RESEARCH REACTOR CENTER

REFERENCE: Docket 50-186
University of Missouri – Columbia Research Reactor
Amended Facility License R-103

SUBJECT: Written communication as specified by 10 CFR 50.4(b)(1) regarding responses to the “University of Missouri at Columbia – Request for Additional Information Re: License Renewal, Safety Analysis Report, Complex Questions (TAC No. MD3034),” dated May 6, 2010, and the “University of Missouri at Columbia – Request for Additional Information Re: License Renewal, Safety Analysis Report, 45-Day Response Questions (TAC No. MD3034),” dated June 1, 2010

Figure 4.a

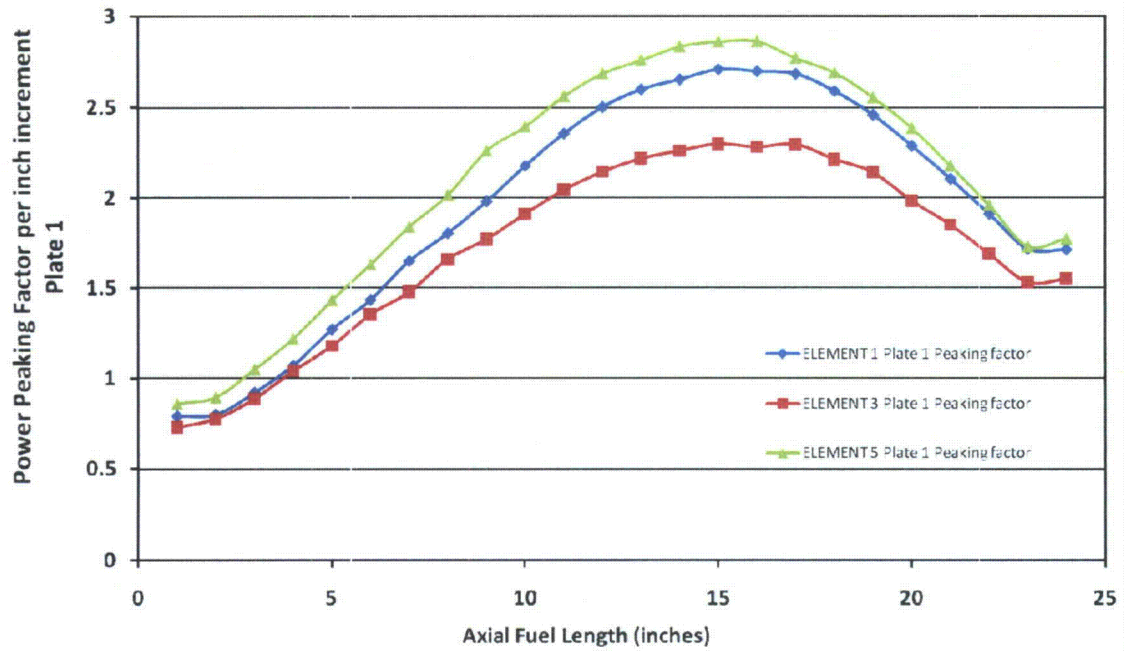
- d. *Page 4-40 and Technical Specification (TS) 3.2.b. Discuss how the one inch limit restricts flux tilting to ensure power peaking factors.*

Considering the power peaking factors for these highest peaking factor configurations with a four-inch difference in the control rod heights do not exceed the SAR Table 4-14 peaking factors, the one inch limit between the highest and lowest control blades when the reactor is at a power level greater than 100 kW insures that an excess in flux tilting is not created.

Figure 1 - Reactor Power Versus Time For Continuous Control Blade Withdrawal Accident (With and Without the Regulating Blade)

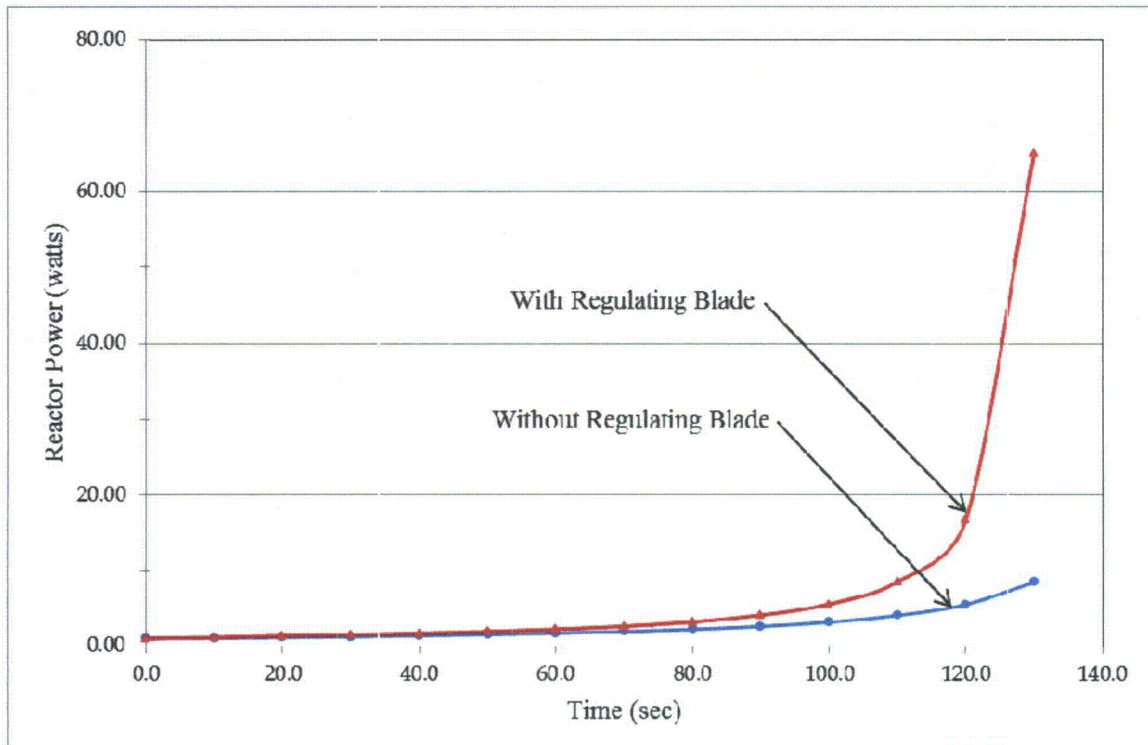
Justify why the regulating blade is not part of this evaluation. Explain if reactor operation in Mode II or III changes the results of the evaluation.

In order to evaluate the consequences of withdrawing the regulating blade at the same time as the four shim blades during a reactor startup, the "Continuous Control Blade Withdrawal" accident, as discussed in SAR Section 13.2.2.1.2, was reanalyzed using the computer code PARET.

For this analysis, the maximum positive reactivity insertion rate allowed by the Technical Specification (TS) due to the withdrawal of the regulating blade was superimposed on top of the maximum allowed reactivity insertion resulting from the simultaneous withdrawal of the four shim blades. It should be noted that since the total reactivity worth of the regulating blade is limited to $0.006 \Delta k/k$ (TS 3.1.c), and at a maximum reactivity addition rate of $0.00025 \Delta k/k/sec$ (also TS 3.1.c), the reactivity addition due to withdrawal of the regulating blade occurs only during the first 24 seconds of the "Continuous Control Blade Withdrawal" accident scenario. Beyond that, the only reactivity addition will be due to shim blade motion. It should also be noted that the current total reactivity worth of the regulating blade is less than half of the TS limit. In addition, by applying the total reactivity worth of the regulating blade using the maximum insertion rate allowed by the TS, very conservative results can be expected. In practice, the regulating blade displays typical control blade worth behavior of a cosine shape, i.e. maximum worth is only in the middle section of the worth curve and much less effect towards either end of blade travel.

The results obtained are shown in Figure 1. As expected, reactor power level reached during the transient is higher when compared to the case where only the four shim blades are continuously withdrawn. Even though the reactivity worth of the regulating blade is considerably less than the reactivity worth of the shim blades, the rate of reactivity addition is significant because of its higher rate of travel (40 inches/min for the regulating blade compared to one inch/min for the shim blades). Figure 1 shows reactor power continuously rising and reaching a value of almost 11.0 kW within 140 seconds of the accident initiation. It should be noted that for this analysis no credit is taken for the reactor protective system initiating a rod run-in or reactor scram once the appropriate short period set points are reached. For example, the short period rod run-in set point is 11 seconds and this value is reached approximately 120 seconds after initiation of the accident (compared to 140 seconds for the shim blade only withdrawal case). At this point, reactor power level is only 17.2 watts. If the reactor protective system fails to initiate a rod run-in, the scram circuit will initiate a reactor scram once reactor period decreases to 9 seconds - which happens about 123 seconds after accident initiation (compared to 143 seconds for the shim blades only case). Reactor power level at this point is only 22.8 watts.

Figure 1- Limiting Channel Plate Axial Peaking Factors and Coolant Temperature Rise Distribution

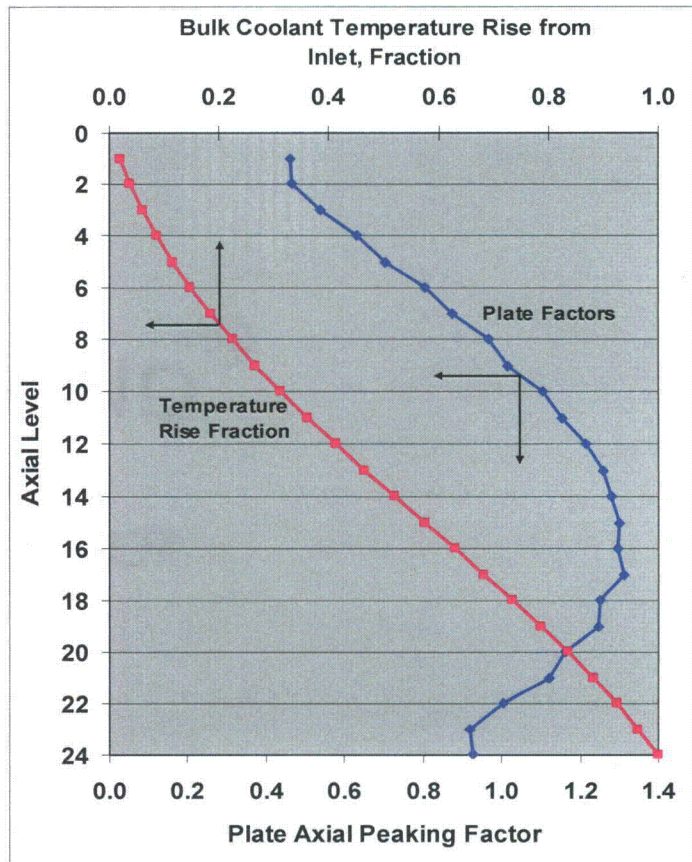
- a. *The bases for TS 3.8.b states that the TS assures that fuel elements found to be defective are no longer used for reactor operation. The TS contains a limit on dimensional changes of coolant channel between fuel plates of 10 mils. What is the basis for the 10 mils and what is the impact of this amount of fuel channel dimensional change on thermal-hydraulic and accident analysis?*

Table 1 and Figure 1 show the axial heat flux peaking factors for fuel plate-1 and coolant channel 2 in fuel element 8, which is the most limiting high burnup element with 142 MWd of burnup. The bulk coolant temperature rise is based on a weighted average of the heat fluxes of the two fuel plates that bound the channel. The corresponding core configuration is for week 58, xenon free (day 0), with an average control rod height of 17 inches withdrawn. In Table 2, the peaking factors for fuel plate-1 and coolant channel 2 of the high burnup fuel element 8 are compared to plate-1 and channel 2 peaking factors of the 0 MWd fuel element 1 in a week 58 core, which is the basis for the MURR SLs. The power peaking factors were obtained from MCNP modeling of the MURR fuel cycle. The MCNP modeling to determine the power peaking factors only included the nominal coolant channel dimensions. If the hot channel 2 had been modeled as narrower, it would have further reduced the power peaking due to the localized reduction in moderation.

As shown in Table 2 below, the power factor for enthalpy rise for element 1 is 2.4416, whereas for element 8 it is 1.8184, a 25% reduction in enthalpy rise, while the channel flow reduction factor was reduced by 22%. The power factor for heat flux in element 1 at interval 18, which is the limiting point, is 3.863, whereas for element 8 at the limiting interval 19 the power factor is 2.504. This corresponds to a 35% reduction in the heat flux at the limiting point. When all of the new factors due to both the reduction in channel size and fuel burnup are in place in the Reference 1 model and the high burnup axial power shape is represented in lines 78 and 79, the 62-mil channel is predicted to reach its maximum SL power level of 19.69 MW. This is 32% larger than the 14.894 MW reactor power SL of Reference 0, demonstrating that for the high burnup fuel element the additional 10-mil reduction in the coolant channel gap creates no safety problem.
